# CONWAY

HISTORIC DISTRICT COMMISSION  
STAFF REPORT

5:30 pm • September 23, 2019 • City Hall

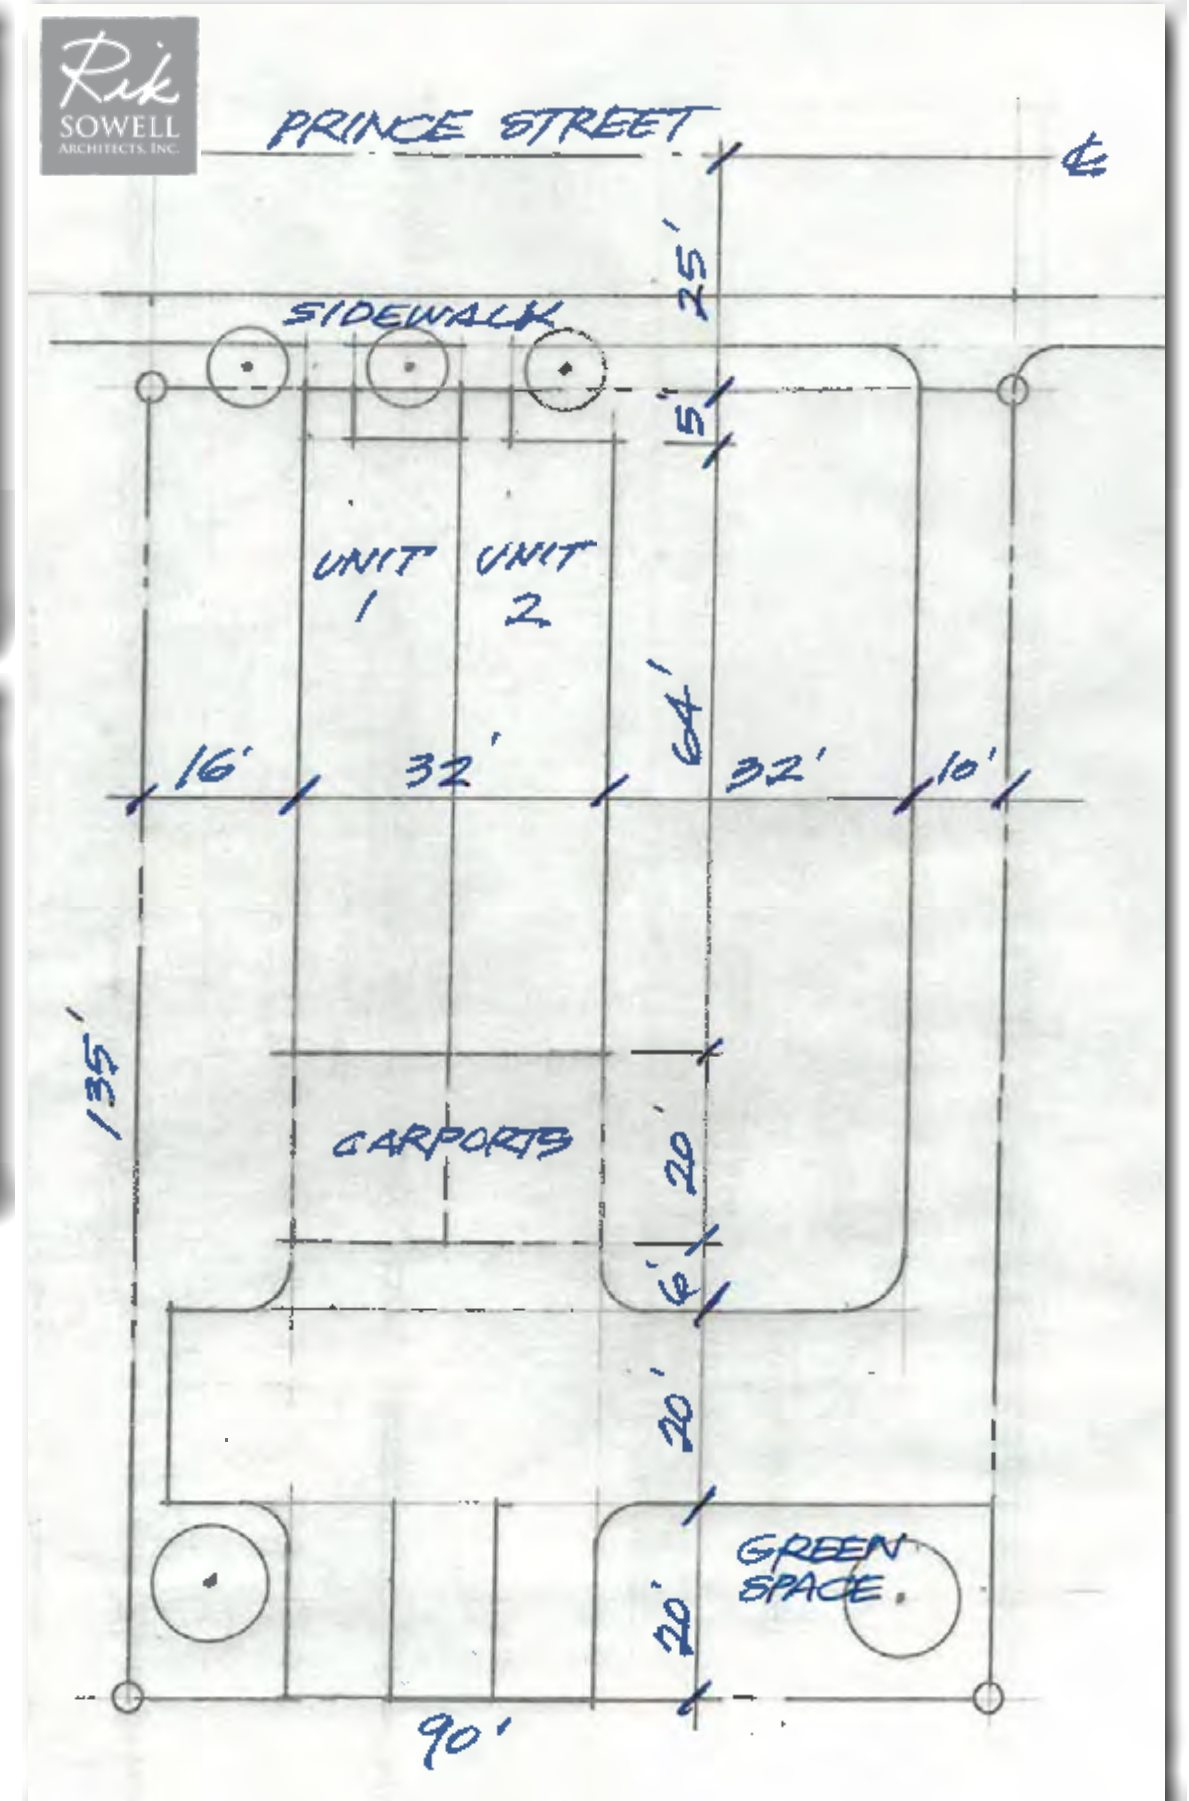
**Setbacks and Spacing.** Front setbacks are allowed within a range of 6 ft. to 18 ft. The included drawings indicate a front setback of 5'. The other proposed setbacks conform to the zoning requirements. Side setbacks are encouraged to be narrow to create a higher density, urbanized environment.

*The proposed setbacks and spacing are not appropriate. Application must be revised to include a conforming front setback of a least 6 ft. Recommend reducing the western side yard setback to 5-7 feet. The current proposed setback would result in a spacing between structures of approximately 38 ft.*

*The front entry will be raised with front steps. Window designs are appropriate in design. Recommend requiring an additional window on the exterior façade of the first floor of both units, and one additional window on the upperstory of the west side façade.*

1. Modify the site plan to increase the front setback to 6 feet.
2. Require an additional window on the exterior façade of the first floor of both units. (May be waived on east façade if intent is to add additional units.)
3. Require an additional window on the exterior façade of the upper floor of both units. (May be waived on east façade if intent is to add additional units.)
4. Indicate type of tree plantings.
5. Require a wooden privacy fence along the east property line.
6. Repair the existing sidewalk.
7. All mechanical shall be placed in a manner to minimize view from the street, and may placed rooftop or along a side or rear façade.
8. The applicant will provide revised plans to the Planning Director for review and approval prior to issuance of building permits.

West Elevation

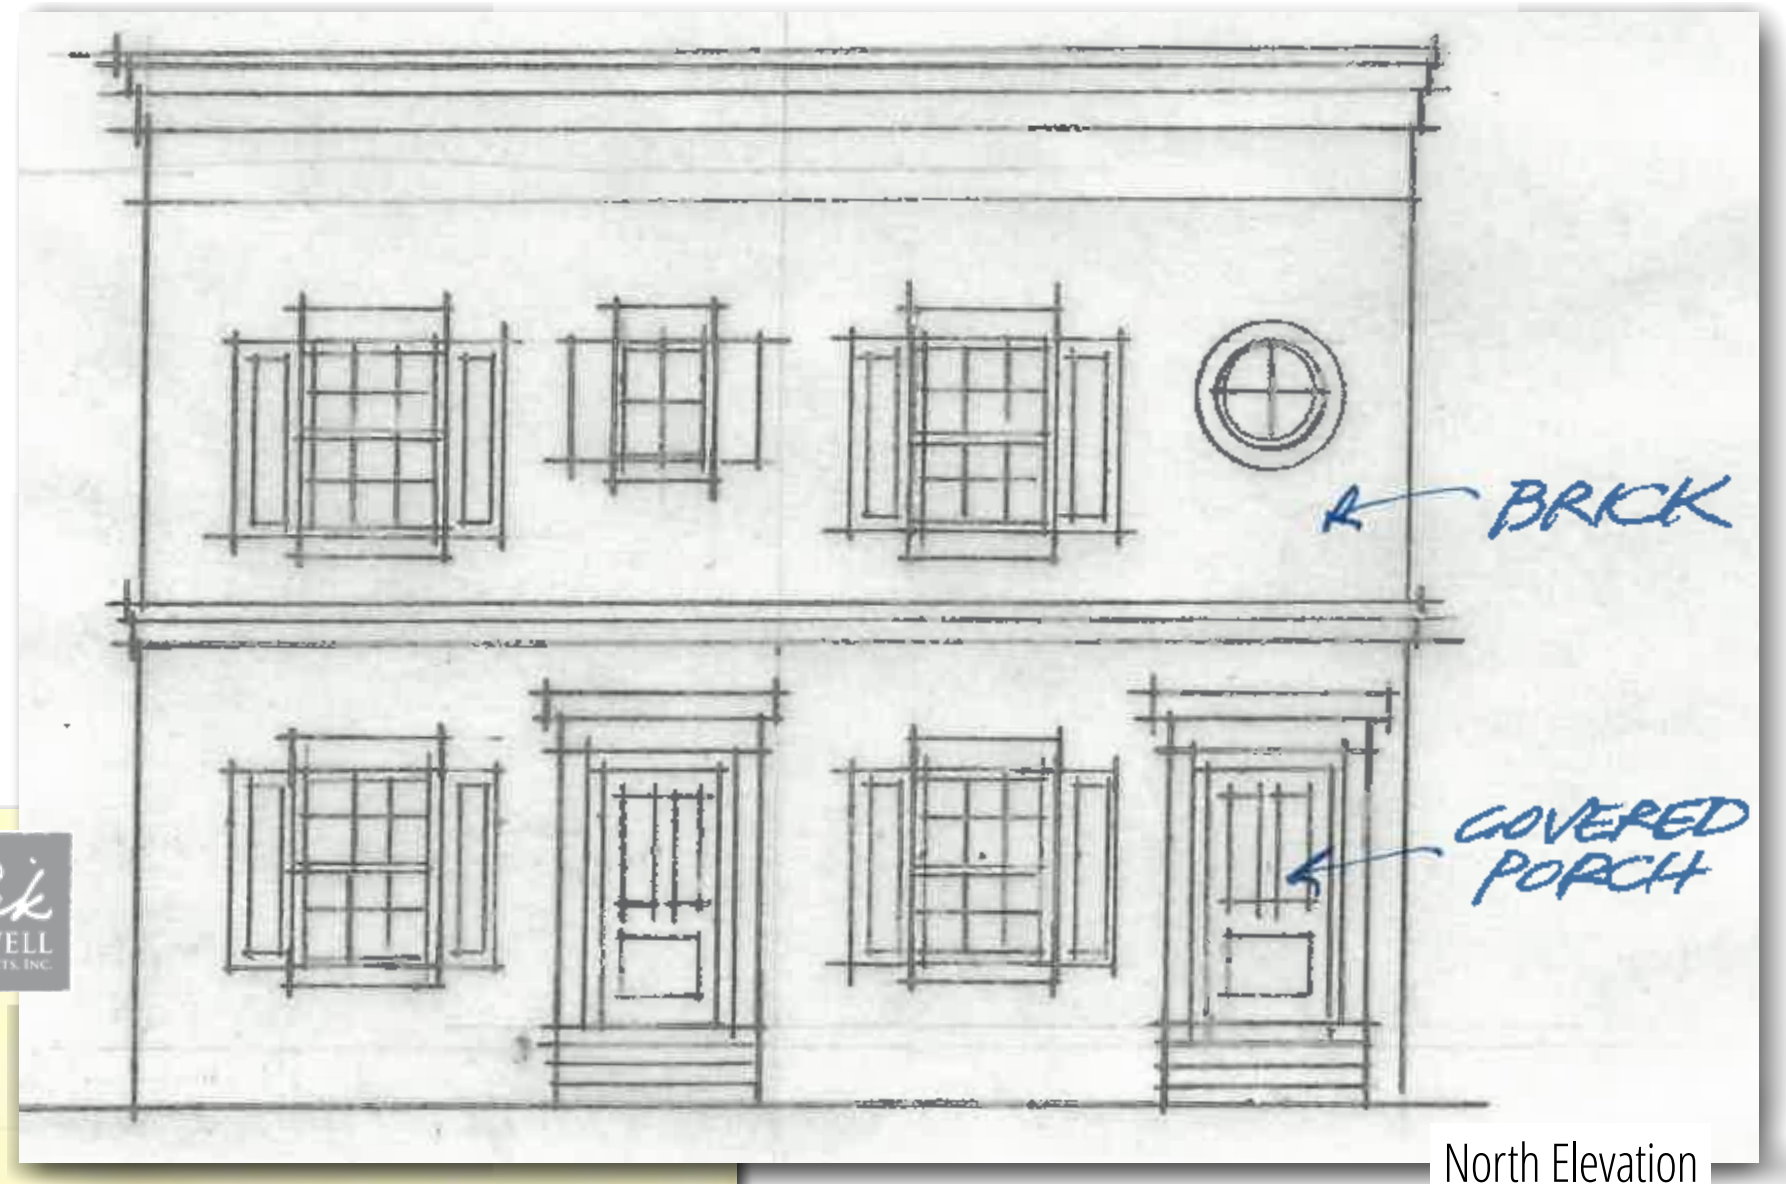
*The structure will be clad with brick and stone veneer. Full brick would be preferable to including stone.*

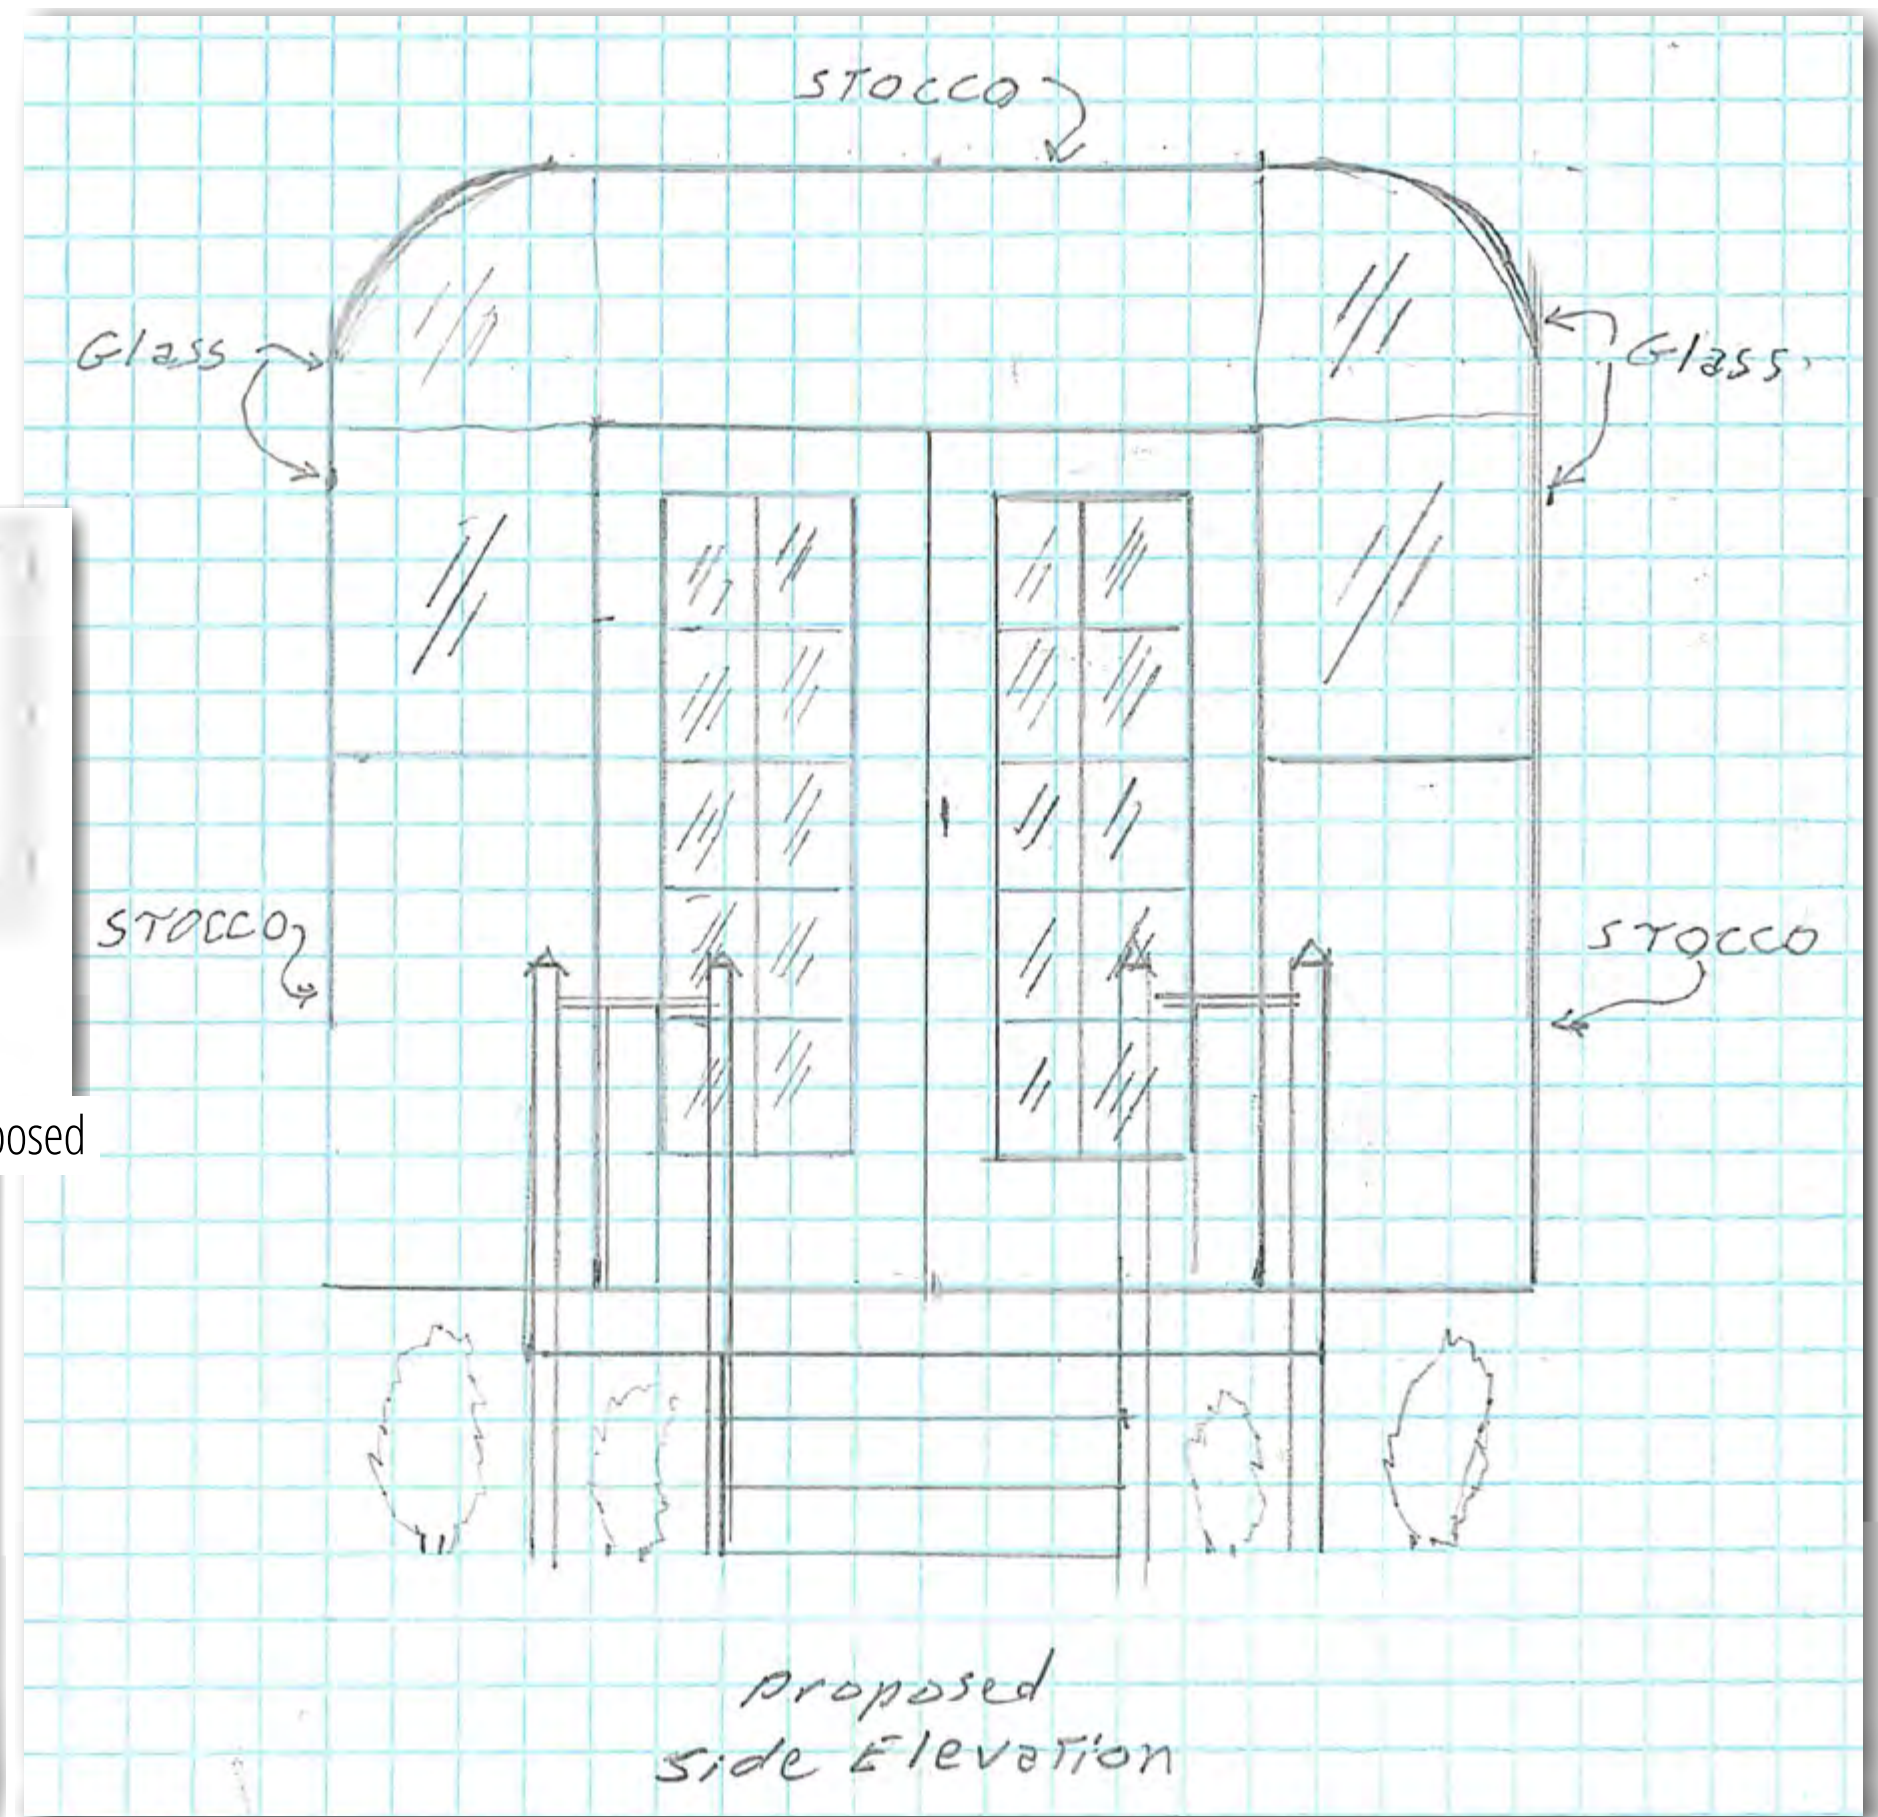
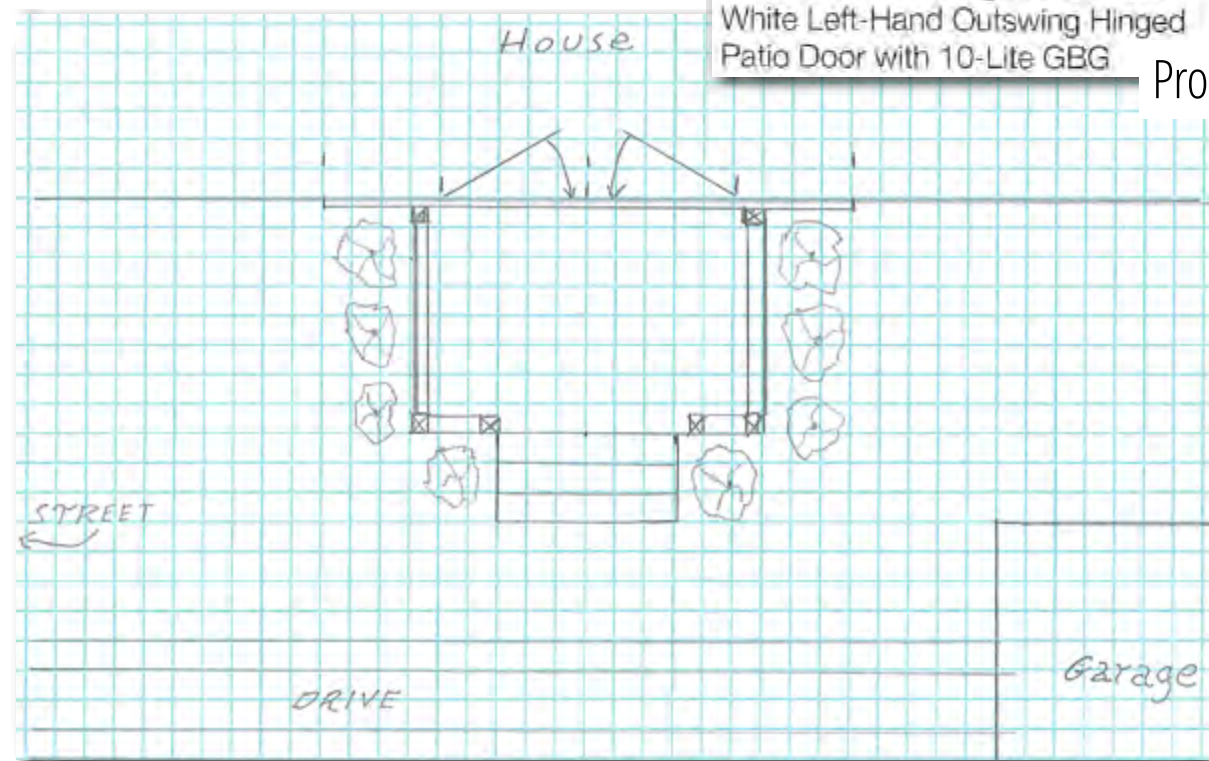
The applicant's proposal shows a combination of windows and stucco to fill the existing voids around the proposed door. The arrangement of the proposed windows are not appropriate to the architectural style of the structure.

The proposed addition indicates four new windows and stucco cap oriented around the proposed door. This configuration is not appropriate. Two sidelight window openings and an arched transom window recommended.

1. All exterior cladding shall be of a stucco masonry material consistent with the existing house.
2. The windows oriented around the new proposed door shall be in the form of two sidelight windows and an arched transom window.
3. The applicant will provide revised plans to the Planning Director for review and approval prior to issuance of building permits.
